Merged Document Report

Application No.: PL8879

Master Preliminary ~~FINAL~~ PLAT OF RIVERSTONE TRAILS MASTER

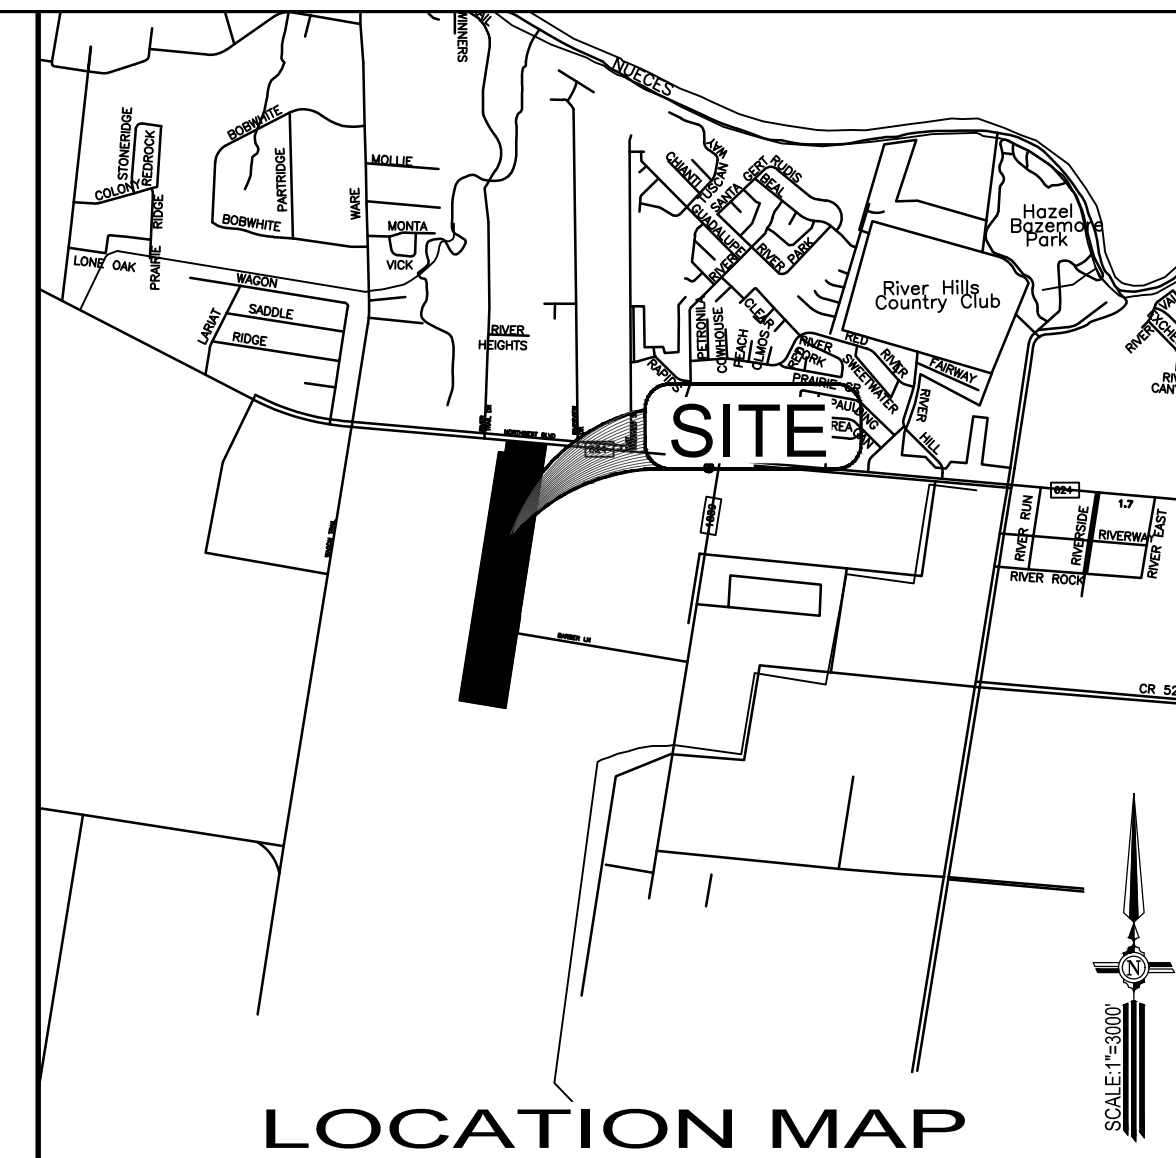
Comment ID	Page Reference	Annotation Type	Author : Department	Status	Review Comments	Applicant Response Comments
25	P001	Note	Alex Harmon : DS	Closed	Provide drainage easement for stormwater infrastructure through lots as shown on drainage layout. While the pond must be shown in a private drainage easement and maintained by HOA, clarify if stormwater infrastructure is proposed to be public or private.	
28	P001	Note	Mina Trinidad : DS	Closed	<p>12/2/25 Update: Will be provided prior to recordation of Final Plat.</p> <p>11/18/2025 Update: Comment not addressed. Provide Homeowners Association record number filed with the county.</p> <p>If a Homeowners Association is to be established, provide a legal instrument that establishes a plan for maintenance and supervision of such improvements per UDC 8.1.8. Home Owners Association.</p>	
29	P001	Note	Mina Trinidad : DS	Closed	<p>11/21/2025 Update: SW comments can be closed. - Melanie B.</p> <p>Public Works/Stormwater (Melanie Barrera) PWSW has the following comments:</p> <ol style="list-style-type: none"> 1. Clearly label lots/areas for detention as private drainage easements 2. Include a note that the City is not responsible for maintenance of private drainage easements 3. What is the proposed distance from outer width of detention pond to property line? Please provide to ensure compliance with UDC 8.2.3.B. <p>Informational: 4. Drainage reports/calcs to be reviewed at final plat/Pls</p>

30	P001	Note	Mina Trinidad : DS	Closed	<p>(Informational as not required until Preliminary Plat)</p> <p>Nueces Electric Cooperative (NEC): NEC would like to verify that there will be a 5' EE (Electrical Easement) in front of properties, parallel with the road, around the cul-de-sac's, and wrap around of blocks to complete loop feed system for this master plan. The plans did not indicate "EE" easements or utility easements for this project.</p>	
31	P001	Note	Alex Harmon : DS	Closed	<p>Show medians from utility plan on Plat. Ensure fire and emergency vehicles including solid waste services can operate around the medians.</p> <p>Medians must be maintained by an HOA and not the City of Corpus Christi.</p>

Comment ID	Page Reference	Annotation Type	Author : Department	Status	Review Comments	Applicant Response Comments
32	P001	Note	Alex Harmon : DS	Closed	Add plat note that medians (shown on utility plan) must be maintained by HOA. City of Corpus Christi will not be responsible for the medians.	
35	P001	Note	Alex Harmon : DS	Closed	<p>12/3/25 UPDATE: Closed per e-mail from Andrew Dimas on 12/3.</p> <p>11/18/25 UPDATE: This should be addressed during the platting process.</p> <p>[Traffic] The following information pertains to The City's Roadway Master Transportation Plan and should be adhered to in the design, platting, and development process. If there is a desire to deviate from the City's accepted plan, the developer may initiate the amendment process to have the proposed design reviewed and considered for acceptance. Please ensure that all design submissions align with the current Roadway Master Transportation Plan (UTP) unless an approved amendment is initiated, accepted, and approved.</p> <p>a.□Cross street 1 "Lake Athens Ave"</p> <p>i.□As per the roadway master plan - C1 collector / Project 1-AB</p> <p>ii.□As per the UDC Section 8.2.1 Streets, Table 8.2.1.C UDC – minor residential collector C1</p> <p>1.□ROW 60 FT (minimum)</p> <p>2.□BB Width 40 FT</p> <p>b.□Cross street 2</p> <p>i.□As per the roadway master plan - A2 Arterial / Project 1-AH</p> <p>ii.□As per the UDC Section 8.2.1 Streets, Table 8.2.1.C – secondary Arterial</p> <p>1.□ROW 100 FT (minimum)</p> <p>2.□BB Width 54 FT</p>

43	P001	Note	Mina Trinidad : DS	Closed	12/2/2025: Comment addressed. 11/18/2025 Update: Comment not addressed Include a legend with a description for the development of each phase with the approximate time frame to be completed.

Comment ID	Page Reference	Annotation Type	Author : Department	Status	Review Comments	Applicant Response Comments
48	P001	Note	Mina Trinidad : DS	Closed	12/2/25 Informational: Ensure general plat note of site acreage matches the acreage in the plat title.	
49	P001	Note	Mina Trinidad : DS	Closed	12/2/2025 Informational: Change "Final Plat" to "Master Preliminary Plat"	
52	P001	Text Strikeout	Mina Trinidad : DS	Closed		
53	P001	Note	Mina Trinidad : DS	Closed	12/2/2025 Informational: Remove signature blocks on plat	
54	P001	Free Text	Mina Trinidad : DS	Closed	Master Preliminary	
69	P001	Free Hand	Mina Trinidad : DS	Closed		
70	P001	Free Hand	Mina Trinidad : DS	Closed		
71	P001	Free Text	Mina Trinidad : DS	Closed	69.213	
55	P002	Free Text	Mina Trinidad : DS	Closed	Master Preliminary	
63	P002	Free Hand	Mina Trinidad : DS	Closed		
64	P002	Text Strikeout	Mina Trinidad : DS	Closed		
14	P003	Note	Alex Harmon : DS	Closed	<p>12/3/25 UPDATE: Closed per e-mail from Andrew Dimas on 12/3.</p> <p>11/18/25 UPDATE: This should be addressed during the platting process.</p> <p>The Roadway Master Plan indicates this should be a secondary arterial road with 100' right of way. Any requests for changes to this must be submitted to the traffic engineering department for consideration.</p>

UTILITY LAYOUT

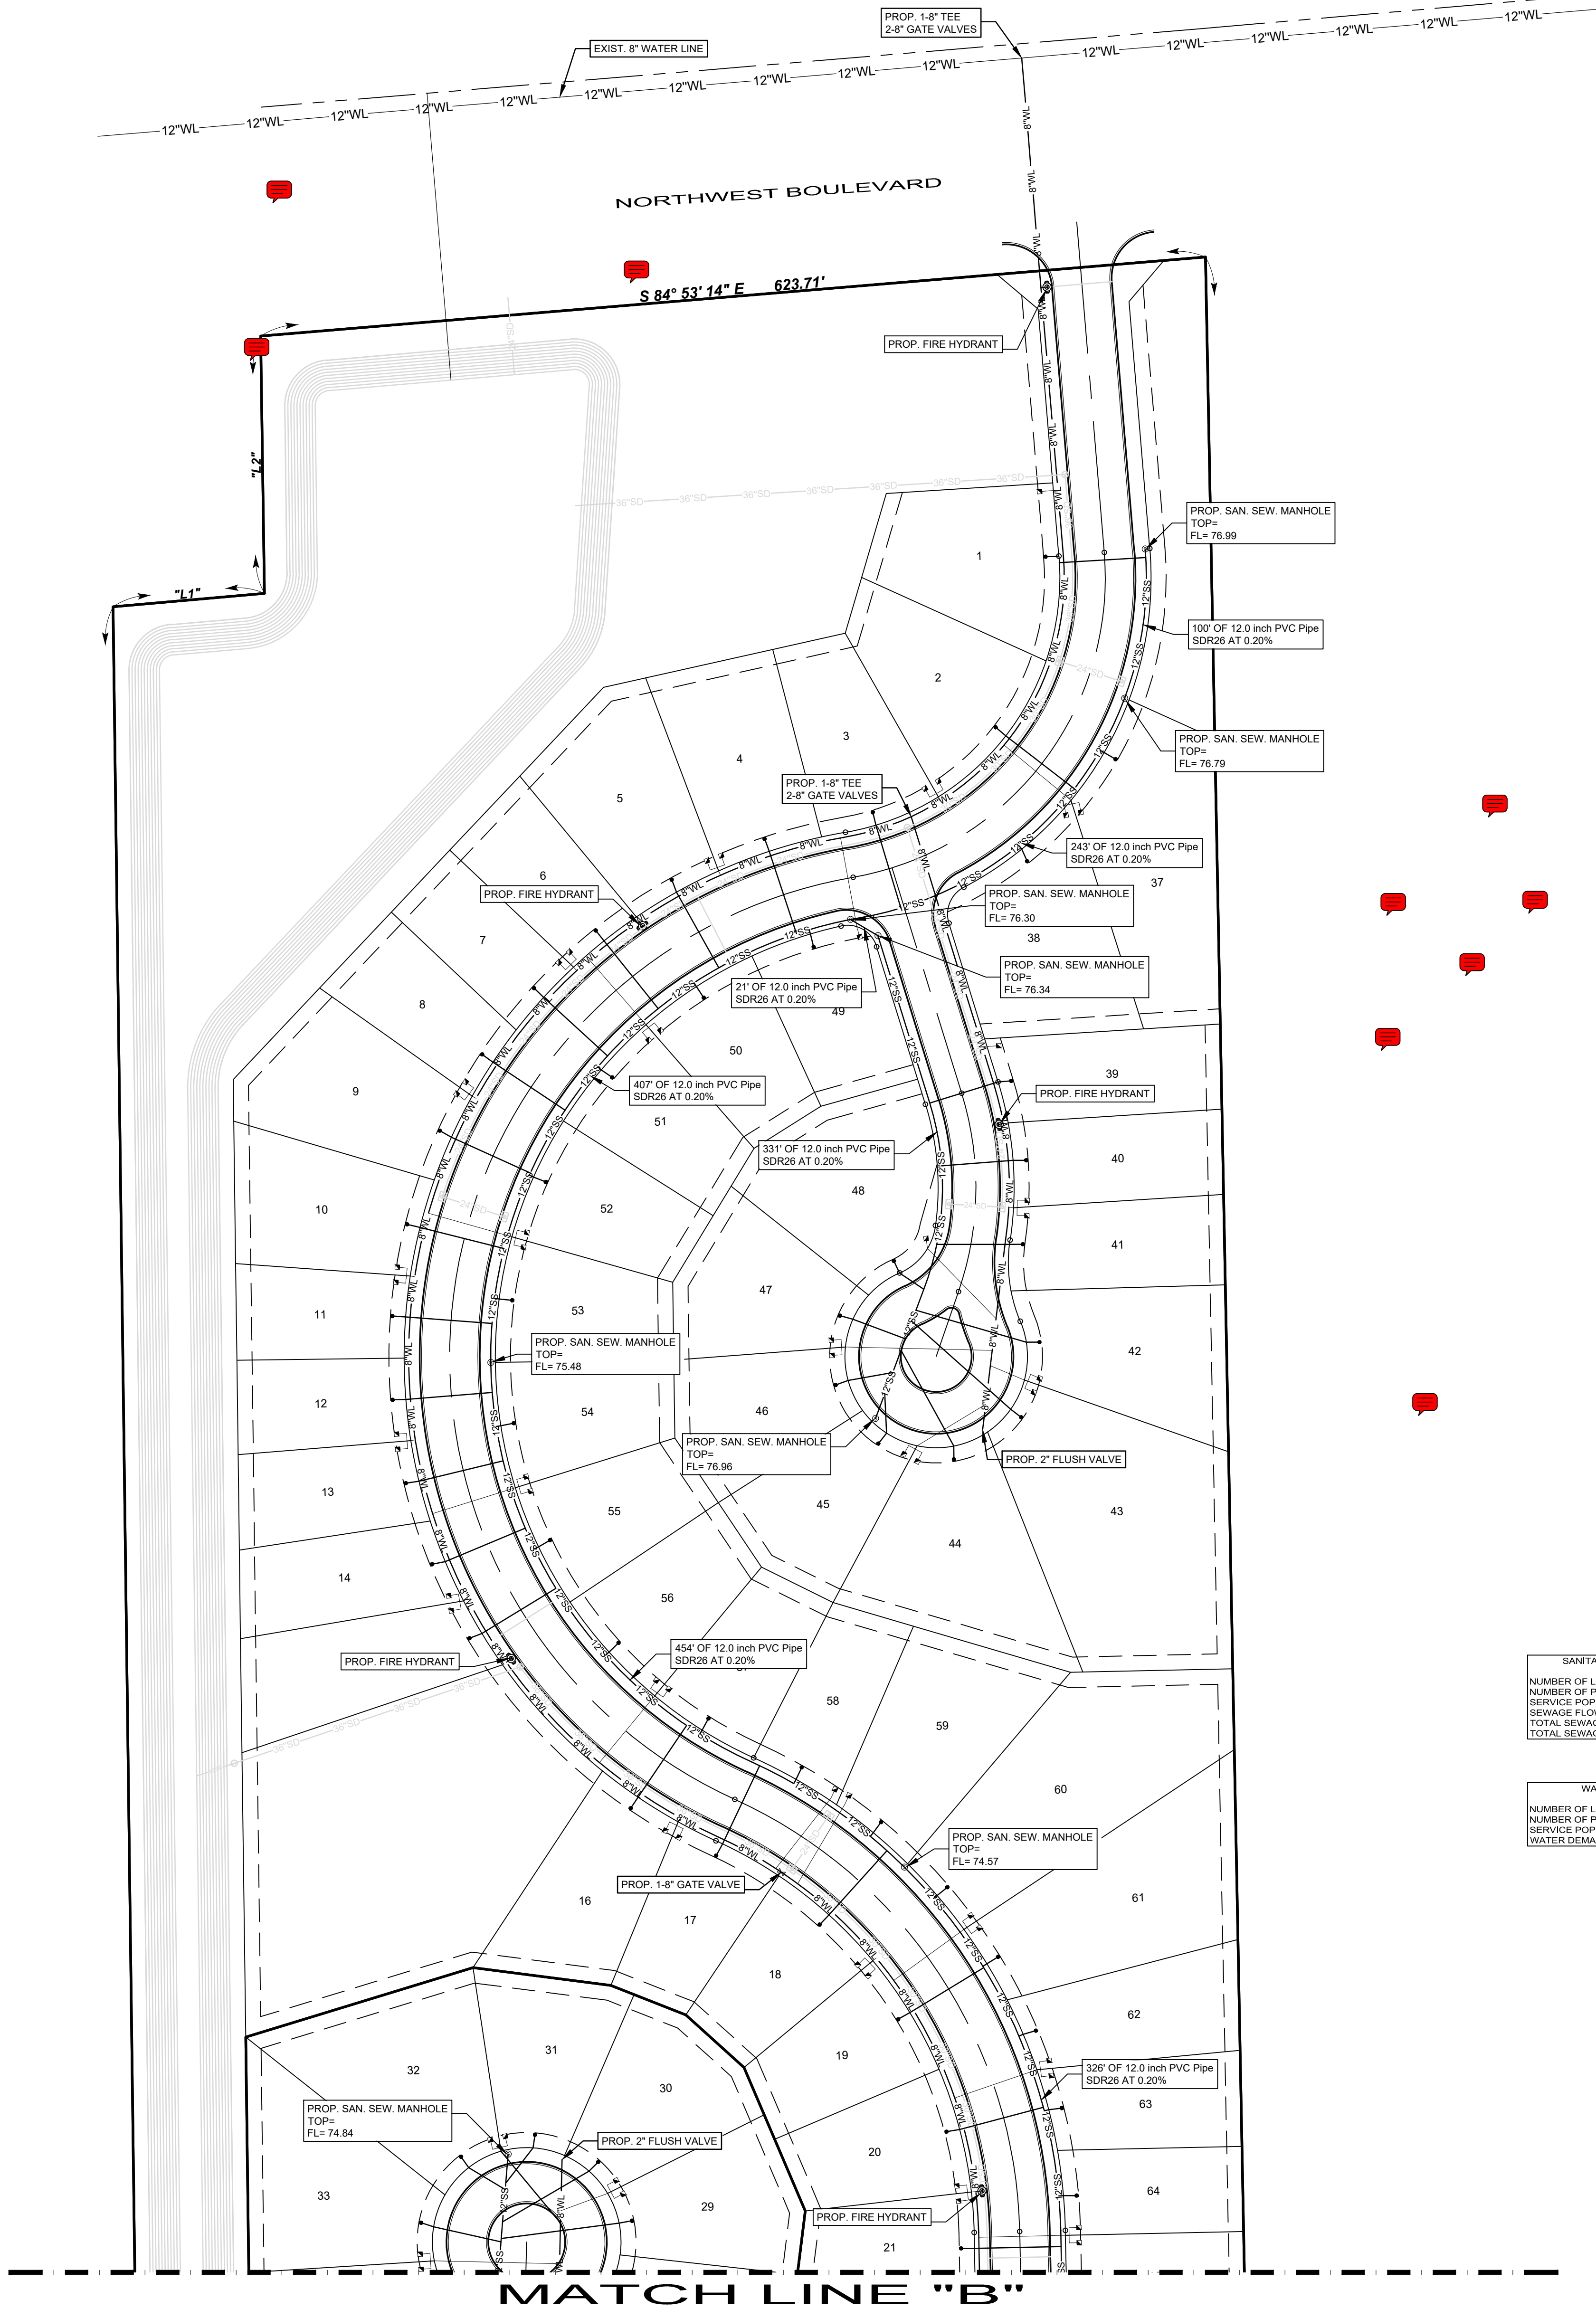
Comment ID	Page Reference	Annotation Type	Author : Department	Status	Review Comments	Applicant Response Comments
23	P004	Note	Alex Harmon : DS	Closed	Approval of the plat does not approve the layout of public utilities, including but not limited to water, wastewater, stormwater and roadways. These items are only approved via Public Improvement Plans, which are required at time of final plat.	
24	P004	Note	Alex Harmon : DS	Closed	11/17/25 UPDATE: Comment response says "DONE" which sheet was this added to? Per UDC 3.7 include estimated water and wastewater usage on utility plan to ensure the proposed development is in compliance with the Comprehensive Plan, implementation plan and applicable Utility Master Plan and the availability and capacity of public improvements needed to support the development. (Flow units gpd)	
24	P004	Note	Alex Harmon : DS	Closed	11/17/25 UPDATE: Comment response says "DONE" which sheet was this added to? Per UDC 3.7 include estimated water and wastewater usage on utility plan to ensure the proposed development is in compliance with the Comprehensive Plan, implementation plan and applicable Utility Master Plan and the availability and capacity of public improvements needed to support the development. (Flow units gpd)

33	P004	Note	Mina Trinidad : DS	Closed	CCW: Update 11/21/25: Comment repeated by CCW (Edgar Diaz Ruiz). 1. Water for this Plat is Not Served by CCW 2. Wastewater construction is required for platting (UDC 1.2.1.D & 8.2.7; Wastewater Collection System Standards). Wastewater utilities will have to be reviewed with a public improvements plan set. The curved sewer lines on this subdivision will be reviewed within a public improvements package.	
33	P004	Note	Mina Trinidad : DS	Closed	CCW: Update 11/21/25: Comment repeated by CCW (Edgar Diaz Ruiz). 1. Water for this Plat is Not Served by CCW 2. Wastewater construction is required for platting (UDC 1.2.1.D & 8.2.7; Wastewater Collection System Standards). Wastewater utilities will have to be reviewed with a public improvements plan set. The curved sewer lines on this subdivision will be reviewed within a public improvements package.
